APPLICATION FOR PERMISSION UNDER SECTION 16 OF THE TOWN PLANNING ORDINANCE (CAP.131)

Application No. 申請編號	(For Official Use Only) (請勿填寫此欄)
Location/address 位置／地址	Lots 1119 S.A, 1119 S.C, 1253, 1254 S.A, 1254 S.B, 1254 S.C, 1254 R.P, 1260 S.A, 1270 S.A in D.D.6 and adjoining Government land, Pun Chun Yuen, Shek Lin Road, Tai Po, New Territories 新界大埔石蓮路半春園丈量約份第6約地段第1119號A分段, 1119 號C分段, 1253號, 1254號A分段, 1254號B分段, 1254號C分段, 1254號餘段, 1260號A分段, 1270號A分段及毗連政府土地
Site area 地盤面積	19,600.9 sq. m 平方米 ☑ About 約 (includes Government land of 包括政府土地 655.1 sq. m 平方米 ☑ About 約)
Plan 圖則	Draft Tai Po Outline Zoning Plan (OZP) No. S/TP/29 大埔分區計劃大綱草圖編號S/TP/29
Zoning 地帶	"Green Belt" ("GB") 「綠化地帶」
Applied use/ development 申請用途/發展	Proposed Columbarium within a Religious Institution 設於宗教機構內的靈灰安置

Job Title:
Section 16 planning application for proposed columbarium at Lots 1119 S.A, 1119 S.C, 1253, 1254 S.A, 1254 S.B, 1254 S.C, 1254 R.P, 1260 S.A, 1270 S.A in D.D.6 and adjoining Government land, Pun Chun Yuen, Shek Lin Road, Tai Po, New Territories

PLANNING STATEMENT

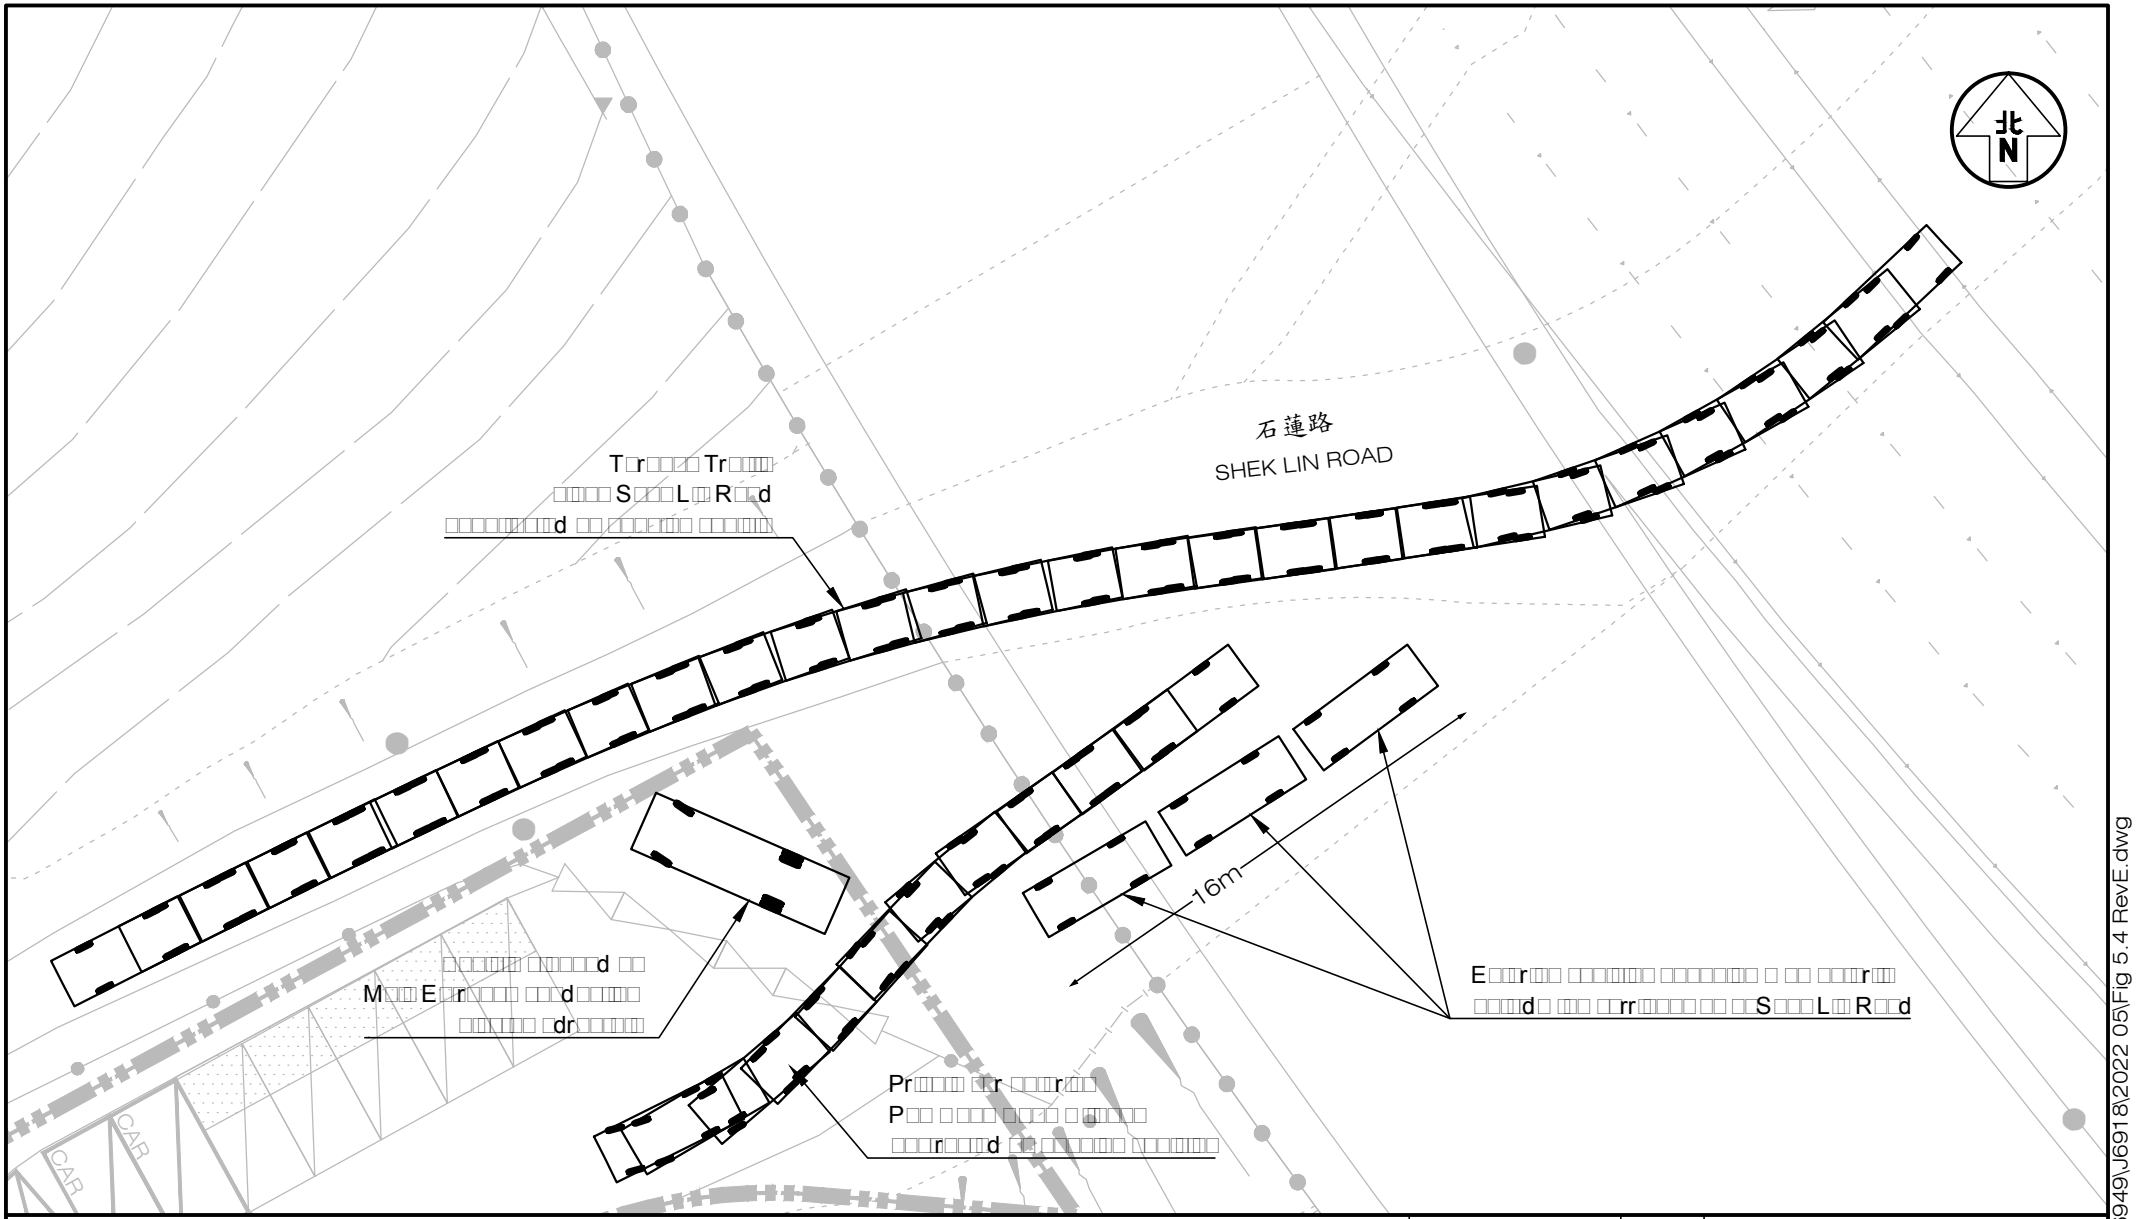
(e) Figure 5.3, the arrangement would block the entrance for private cars.	Our response to comment (e) The entrance will not be blocked with the revised arrangement.

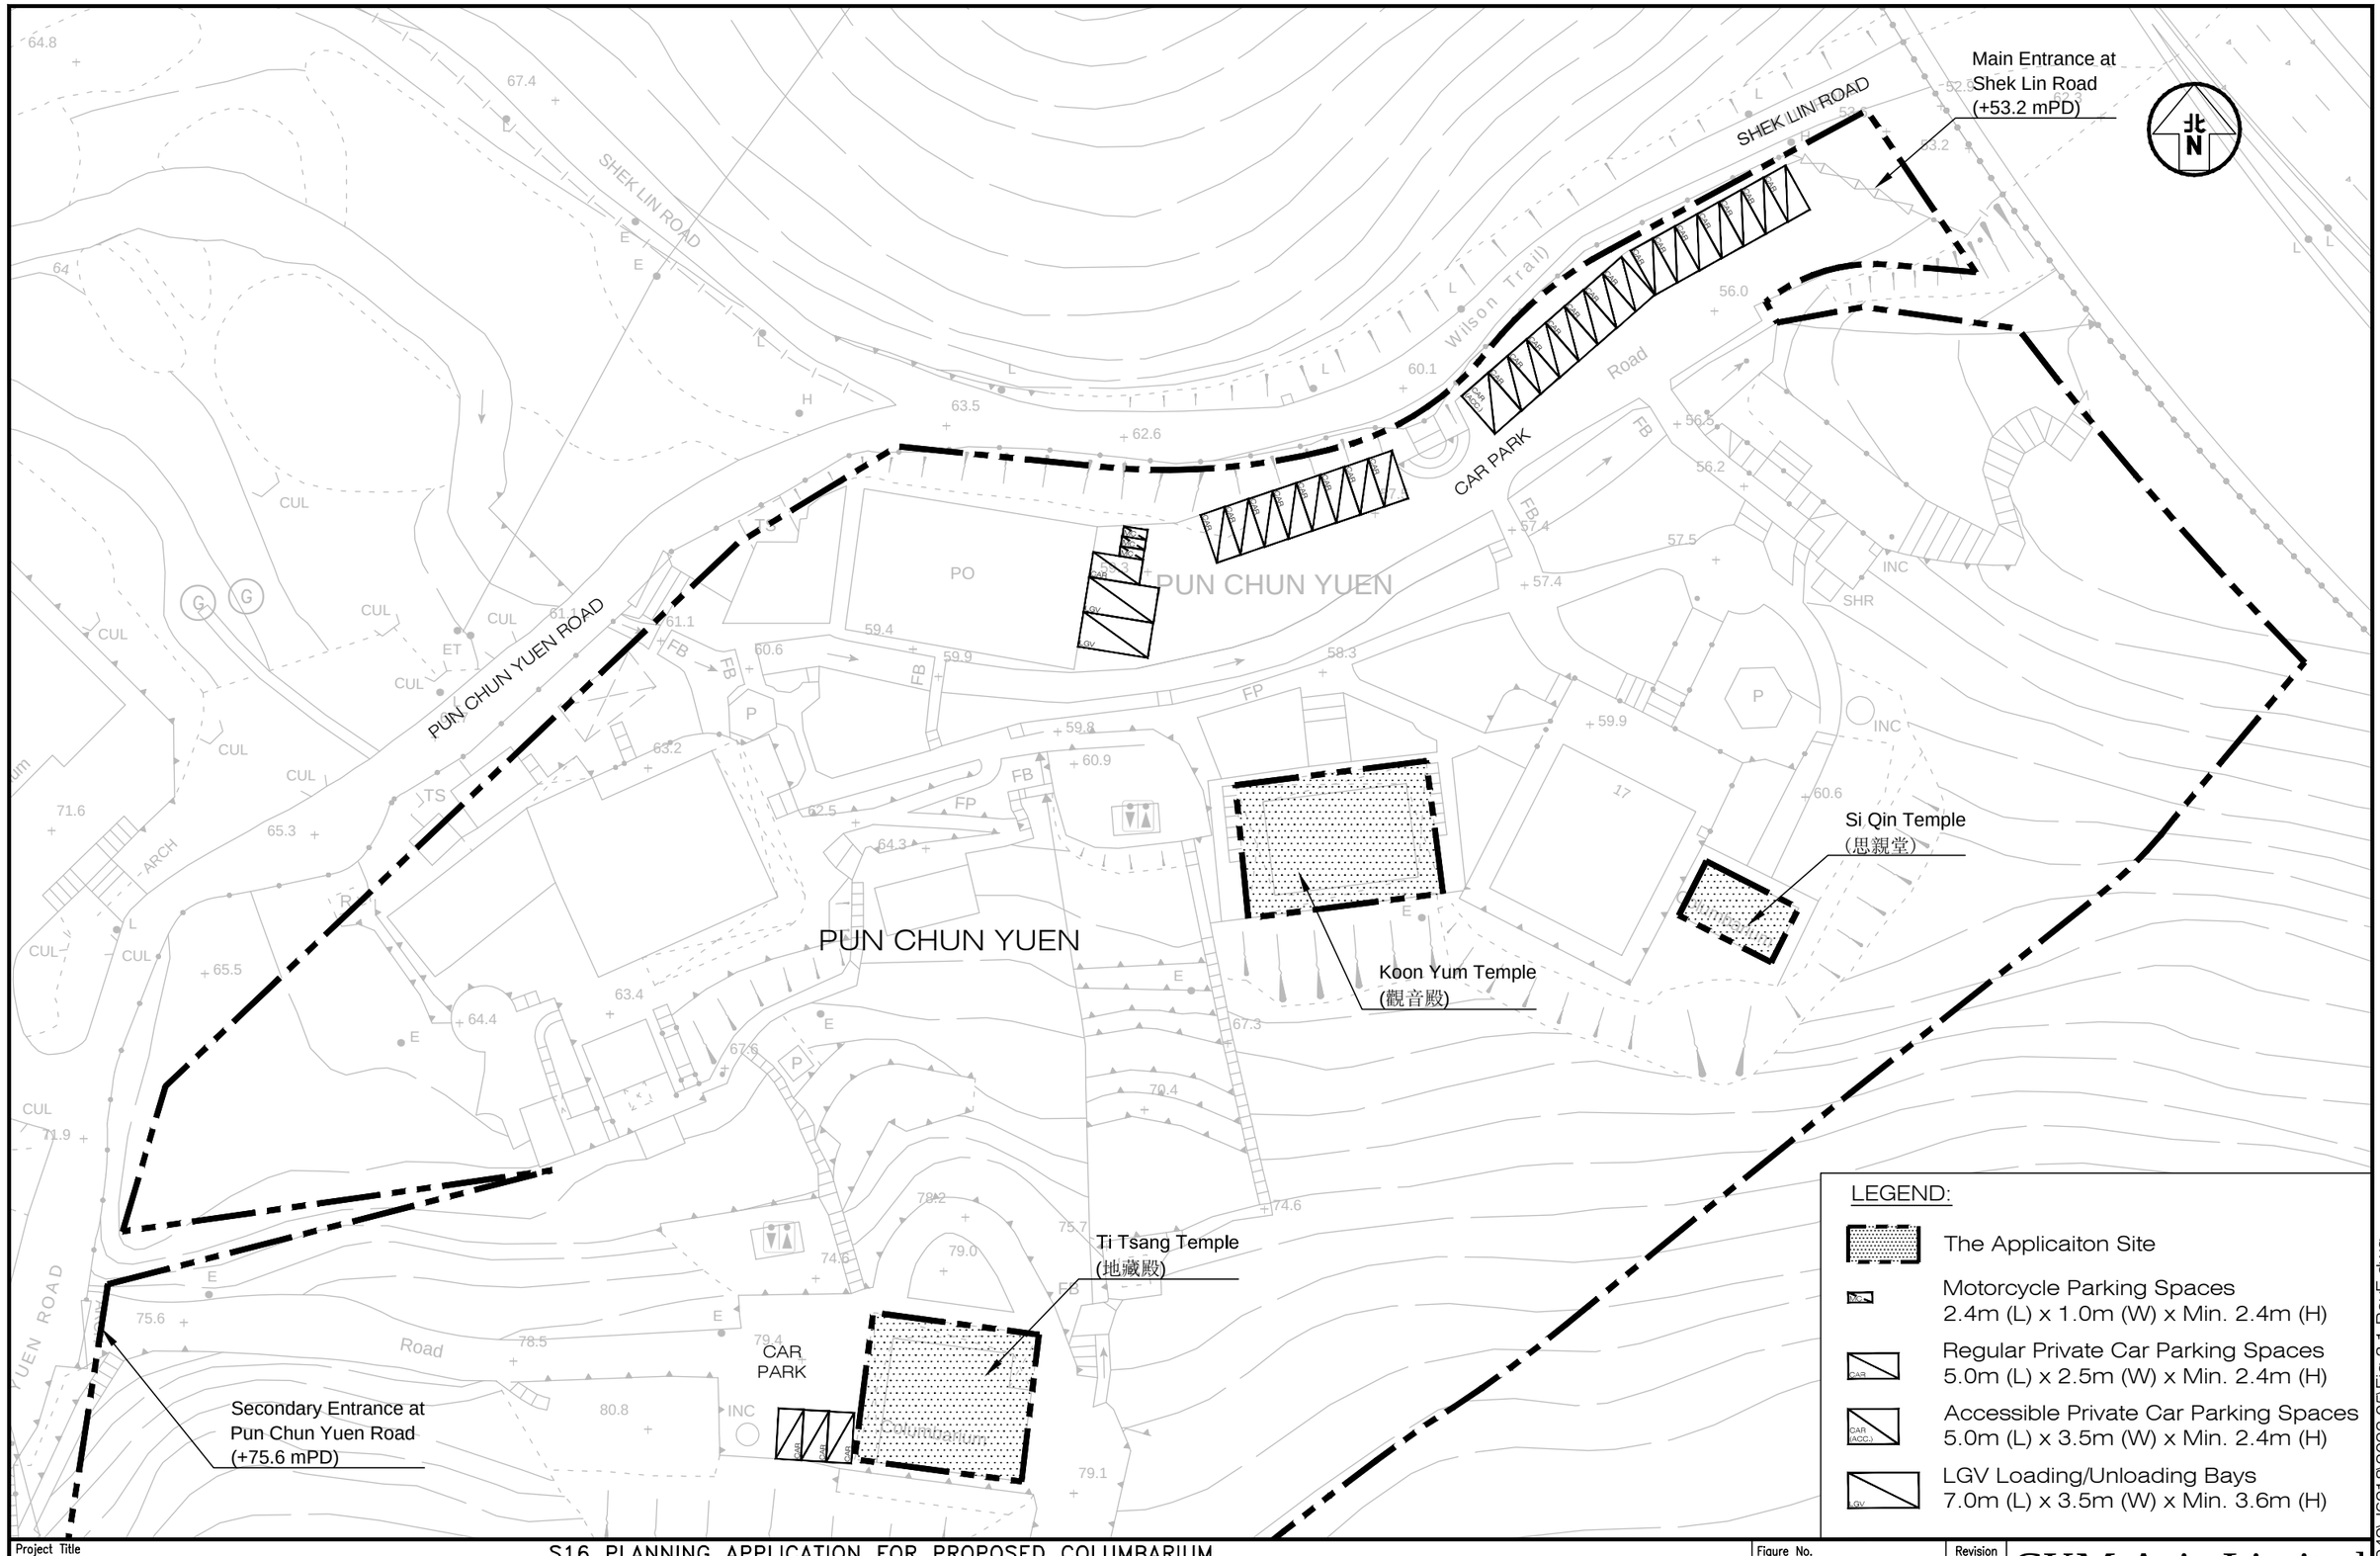
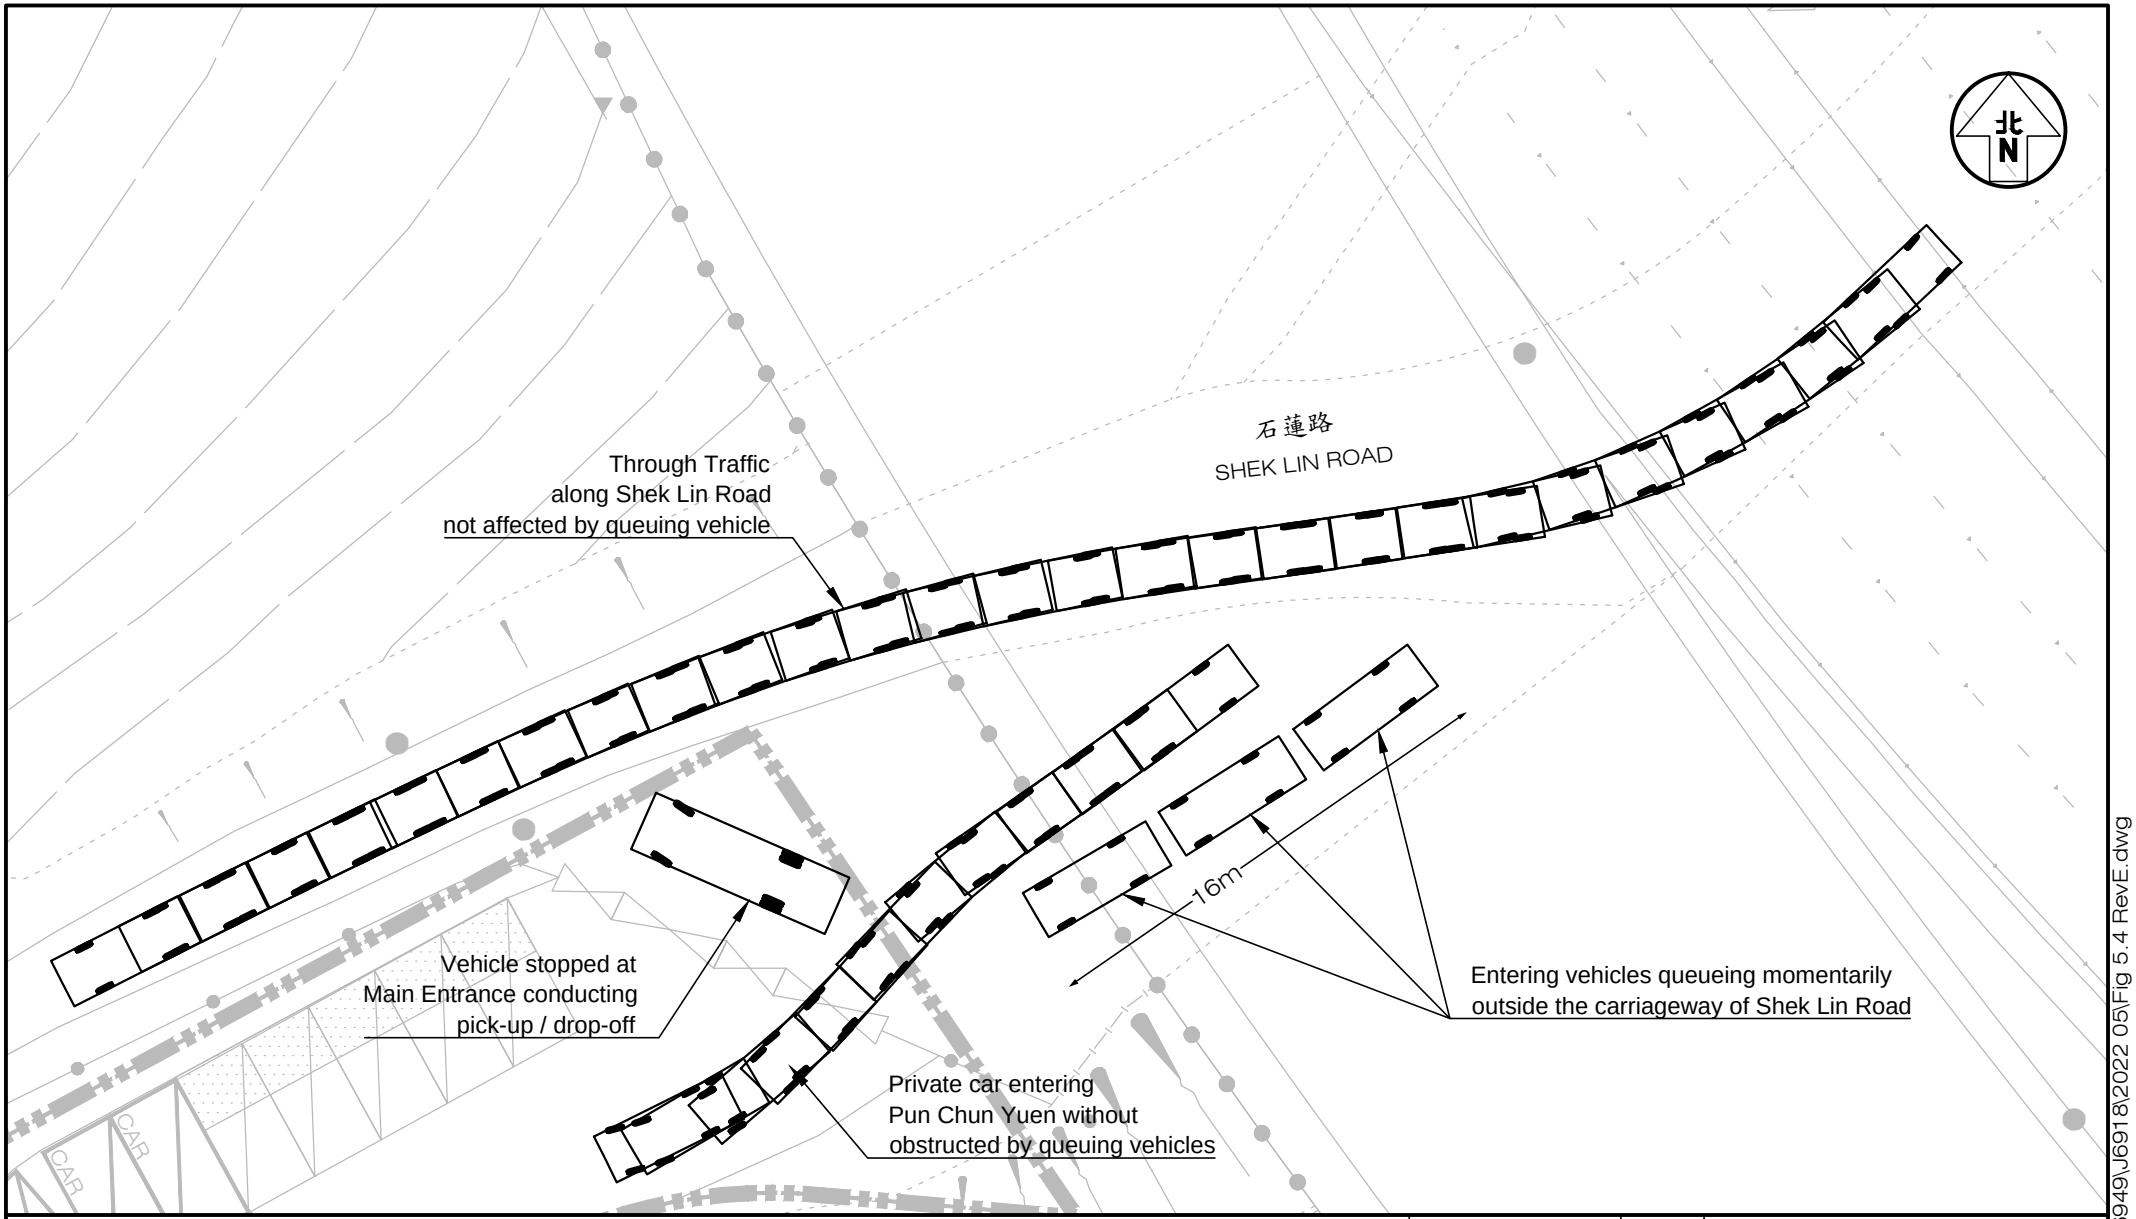
Comments from Government Departments	Applicant's Responses
Comments from TD on 26.7.2022	
In Fig. 3.1, 4.1 and 5.4 of the TIA, some of the words are not shown. The applicant shall provide replacement pages.	We have enclosed the replacement pages for Figures 3.1, 4.1 and 5.4.
Comments from TD on 8.8.2022	
It is noted that the applicant's R-to-C table has still not addressed our comments (c) in our reply memo ref. (NJWE6) in TD NR 157/161/TPDD-6 dated 29 Mar 2022. Clarification from applicant is required. "Comment (c) Figure 5.3, it is noted that some of the pick-up / drop-off areas outside the application site are fallen within government land, and the relevant maintenance and management parties should be consulted regarding the proposed uses.	For clarification, the pick-up / drop-off activities will only be carried our **within the site boundary** of Pun Chun Yuen. Vehicles shown outside the site boundary in Figure 5.4 are only to demonstrate that the available temporary queuing spaces alongside Shek Lin Road for vehicles waiting to enter Pun Chun Yuen. These waiting vehicles shall stop momentarily outside the carriageway of Shek Lin Road and will not affect the movement of through traffic. It should be noted that **NO** pick-up / drop-off will be carried out within government land, hence, it is opined that *"the relevant maintenance and management parties should be consulted regarding the proposed uses"* is not required. Staff will be deployed to monitor and facilitate the operation of pick-up / drop-off activities within the site boundary when the TCMP is implemented during the festive periods.

Further to our application submitted on behalf of Lotus Association of Hong Kong to the Town Planning Board (the Board) on 28.12.2021, the Applicant submits, firstly, the replacement Figures 3.1, 4.1 and 5.4 of the TIA report as per request by Transport Department on 26.7.2022 and our clarifications to queries on Figure 5.4 of the TIA report also by Transport Department on 8.8.2022.
